# PERMIT

## SEWAGE DISPOSAL SYSTEM

### HOWARD COUNTY

SUBDIVISION Greenwood Farms ROAD 7523 Greenwood Drive LOT \_\_\_\_\_

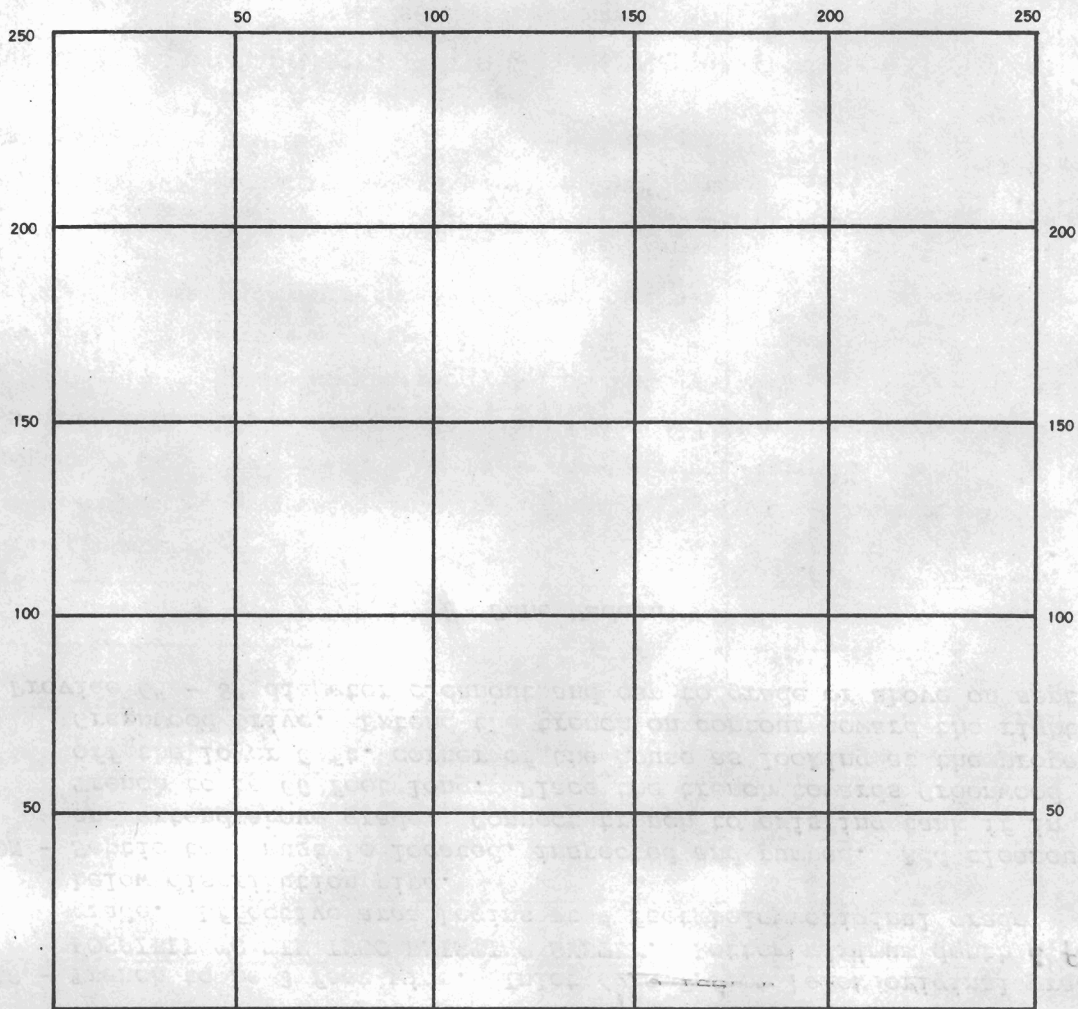
DISCONNECT 60' OF TRENCH AT GARAGE LOCATION, REPLACE WITH 60' OF NEW TRENCH AS SPECIFIED BELOW CW

TRENCHES - Trench to be 3 feet wide. Inlet ~~4 1/2 to 5~~ feet below original grade. AS HIGH AS POSSIBLE TO TIE INTO EXISTING SYSTEM. Bottom maximum depth 6 1/2 feet below original grade. Effective area begins at 4 feet below original grade. 2 feet of stone below distribution pipe.

LOCATION - Septic tank must be located, inspected and pumped. Add cleanout to septic tank and extend above grade. Connect trench to existing tank if in good condition. Trench to be 60 feet long. Place the trench towards Greenwood Drive and 25 feet off the lower 6 ft. corner of the house as looking at the property from Greenwood Drive. Extend the trench on contour toward the right property line.

NOTE: Provide 6" - 8" diameter cleanout and cap to grade or above on septic tank. OK/CW

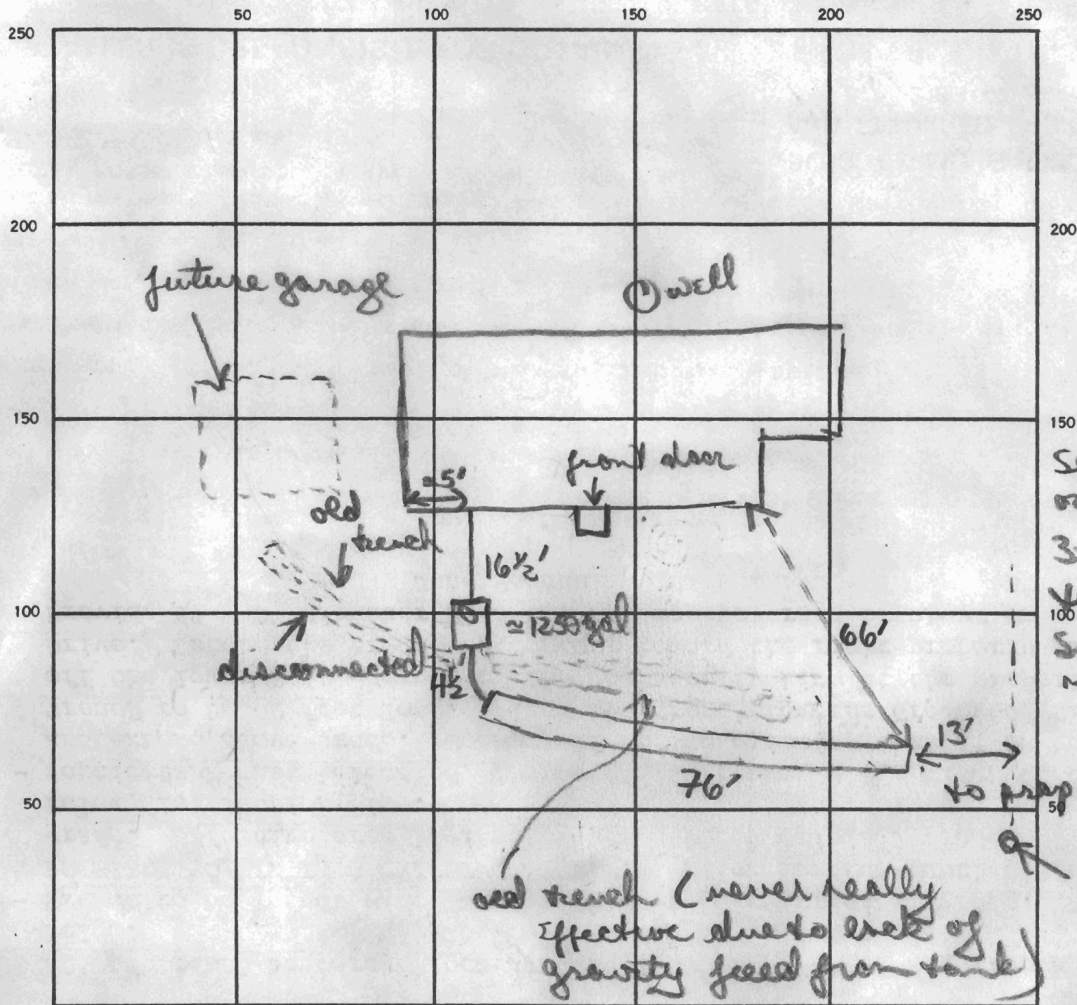
existing 1250 gal

(old 8" c/o) replace w/  
new c/o on septic tank  
OK CLEANOUT

REMARKS 3/8/88 OLD trench(es) in front of house with future proposed garage area disconnected. New trench installed next to original trench in front of house. OK to add stone pipe paper to trench. OK to partial cover. OK to install S.T. c/o to grade. 3/9/88 CLEANOUT OK & STONE PIPE ADDED TO TRENCH

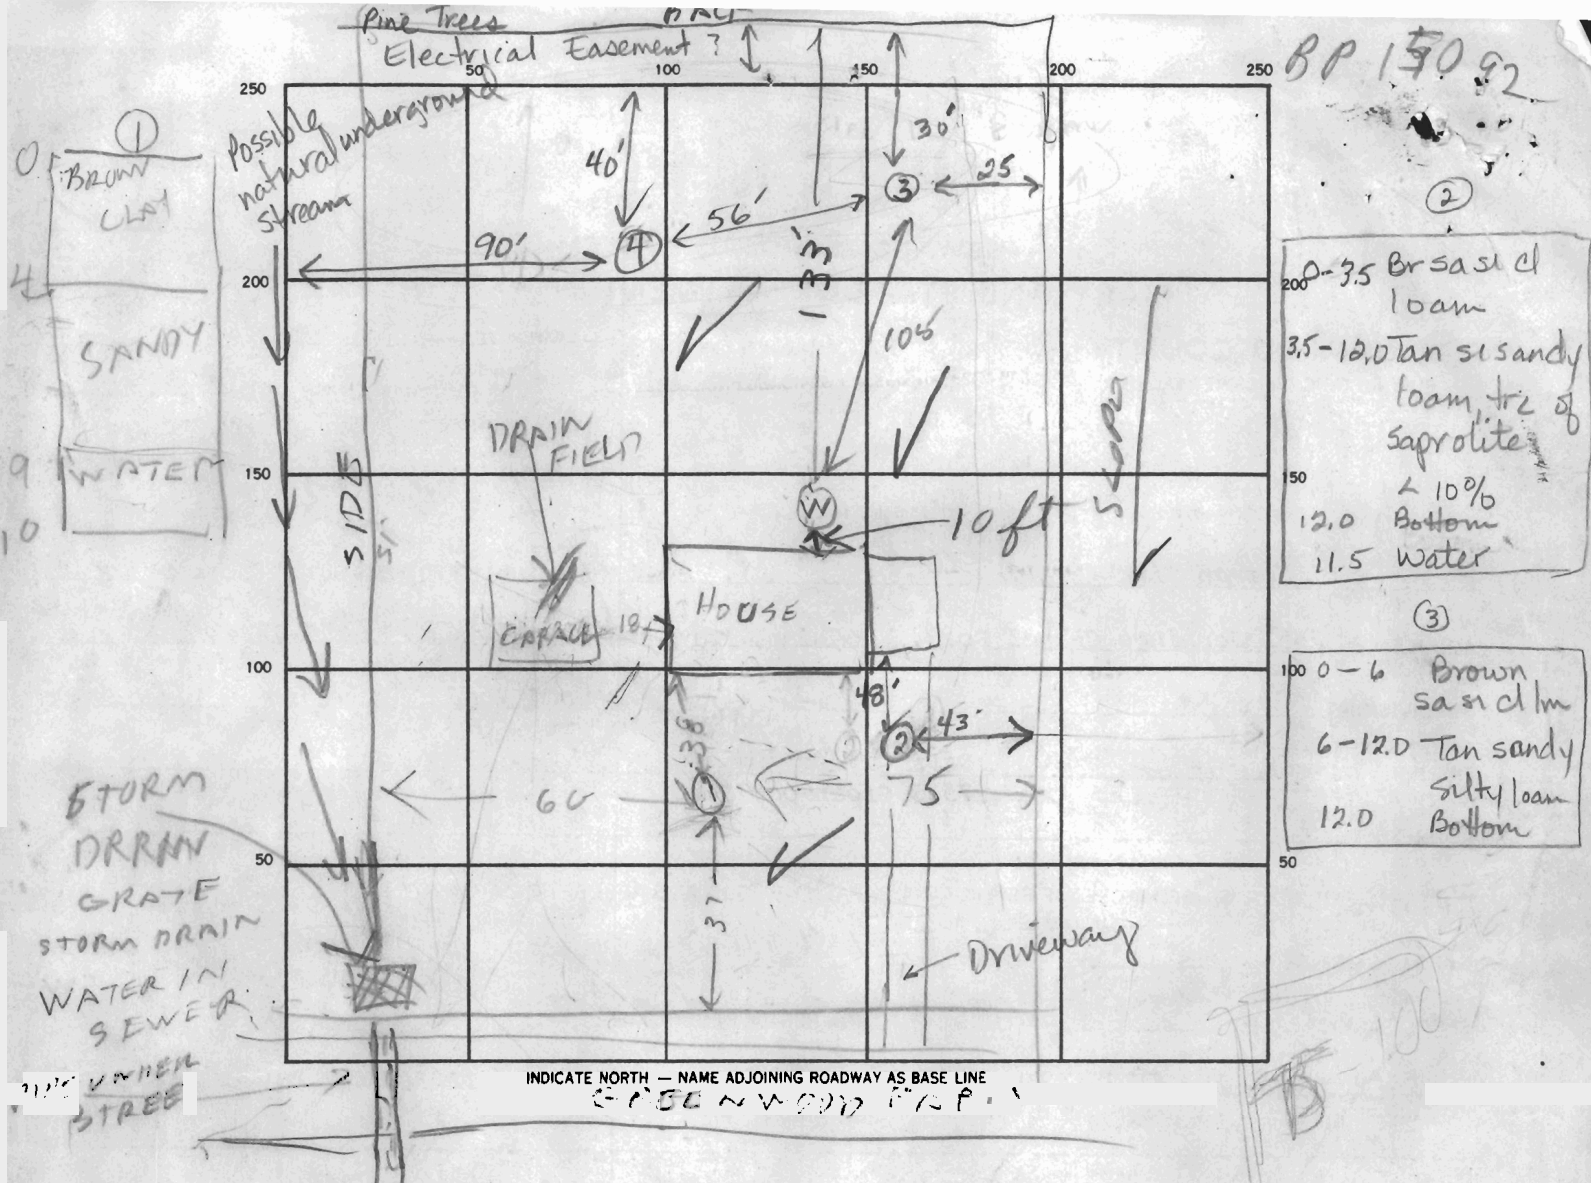
0-3.5 Br sasi cl loam  
 3.5-12.0 Tan si sandy loam, trz of Saprolite  
 < 10%  
 12.0 Bottom  
 11.5 Water

0-6 Brown sasi cl lm  
 6-12.0 Tan sandy silty loam  
 12.0 Bottom

REMARKS 12/16/97 - FOUNDATION FOR GARAGE CUTS INTO  
EXISTING DRAIN FIELD HOLD FOR DISCUSSION WITH CRAIG RIT 12-17-87  
 (2) opened up a tip of the old drainfield, bottom at 5.0 ft, not damaged, water at 11.5 ft  
 (3) 12 ft ok, (4) water at 11.5 ft. Dye test did not show up in storm drain or foundation  
 for proposed garage. Red in bathtub, Blue in basement toilet. Told owner, trench  
 under foundation would probably have to be removed and disposed of properly. JEN
